I am writing to object to SSD-96272465 (11-23 Rangers Avenue, Mosman) specifically as it concerns my property but also more generally because the EIS (and many of its supporting documents) contain substantial errors, omissions and misleading statements.

Site Isolation and reasonable development potential of 9 & 9A Rangers

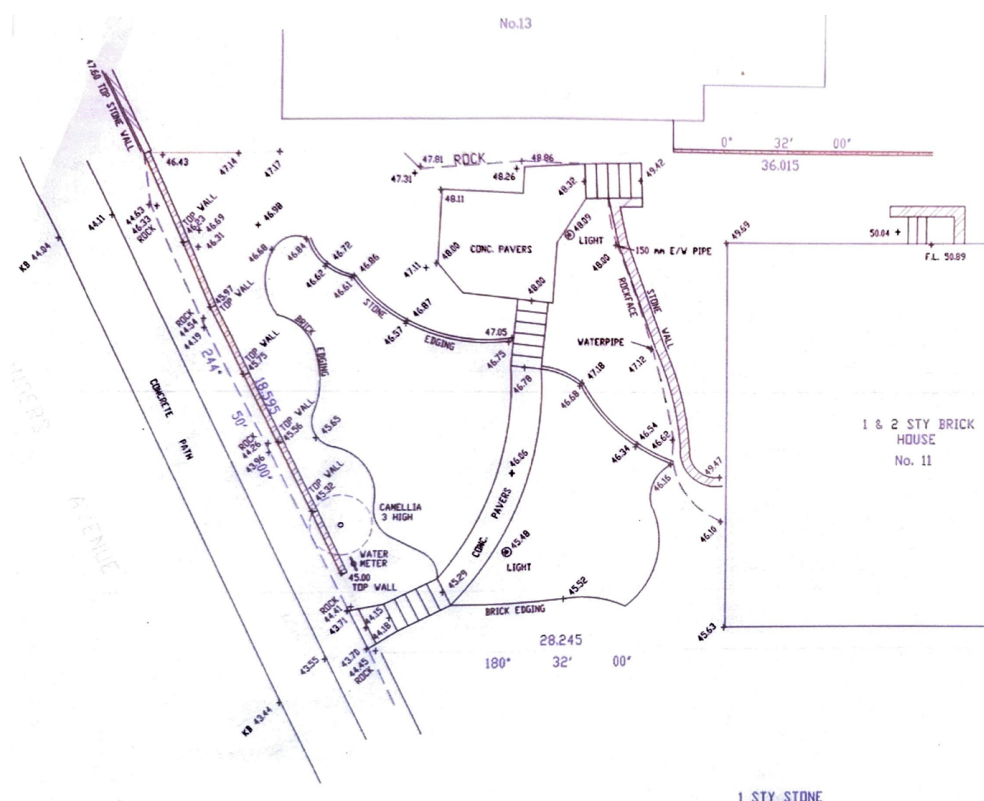
Therefore, an excavation of at least 1700mm would need to occur along the western building envelope to achieve the predetermined ground level height as proposed by the Applicant at the western end. Conversely, at the eastern end, the Applicant proposes to raise the height of the existing ground level by 2.431 metres (RL 48.66 (FFL), RL 46.229).

The construction of this retaining wall is actually 2.943 metres higher than the existing natural ground level where the existing timber boundary fence between 9 & 11 Rangers is located.

Stepping Down the Buildings WEST to EAST is a solution

Given the topography and considering both natural and existing ground levels, the only reasonable solution would be for the three (3) buildings to be progressively stepped down to reflect reality and to achieve an orderly planning outcome.

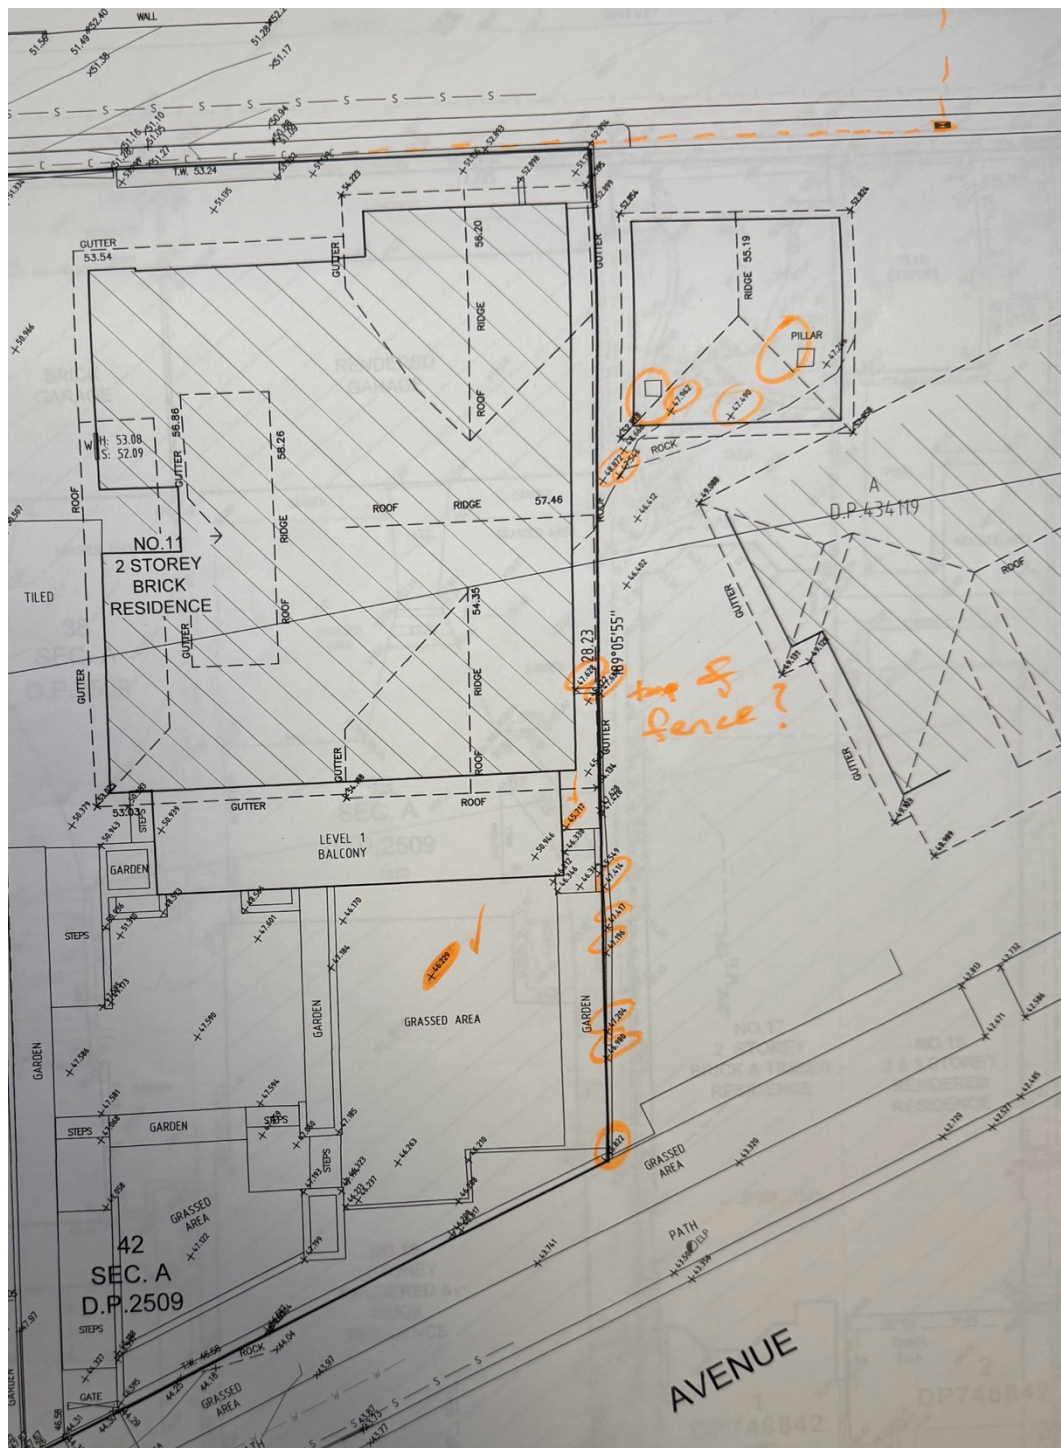
Photo 3 below was taken Saturday 6 December at 11:40am looks south easterly (toward the Avenue Road intersection and demonstrates the traffic build up that occurs at differing times on weekends and public holidays.

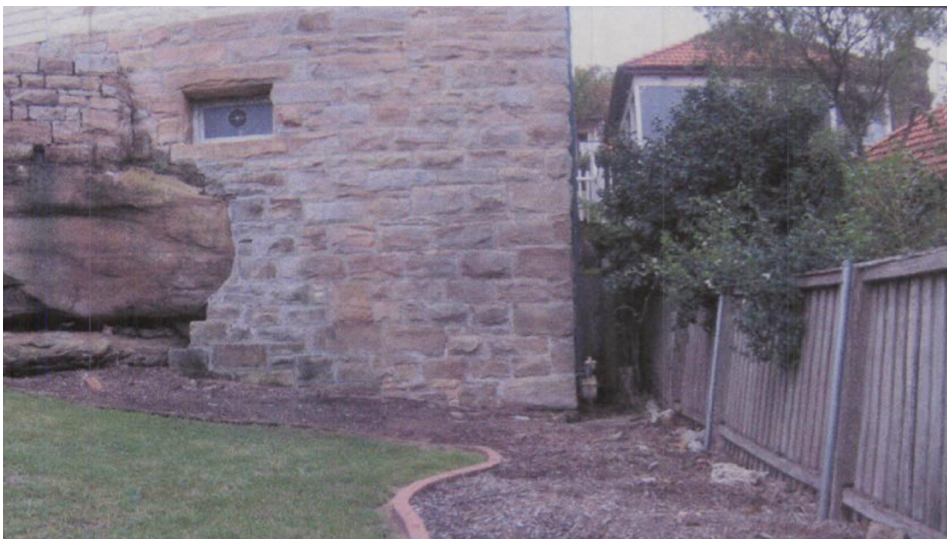
The survey has not accurately located the two (2) pillars that support the southern end of the concrete slab of the double garage. Furthermore, the westerly pillar is depicted more as a quadrilateral rather than as a square (from a cross-sectional perspective). Of course, the pillars are rectangular prisms.

The accurate location of the pillars is important because at the nearest point of projection, the western pillar is approximately 1400mm from the boundary. Clearly, vibration monitoring will be required and accurate assessments and calculations made by engineers. Accurate information is crucial for the safety of persons and as well as the double garage, landing bridge and house.

The RL's in the vicinity of the pillars (47.962, 47.490 & 47.2) appear incongruous with the RL 48.872 near the 11 Rangers house foundation at the existing and natural ground level. just north of the roof ridge line.
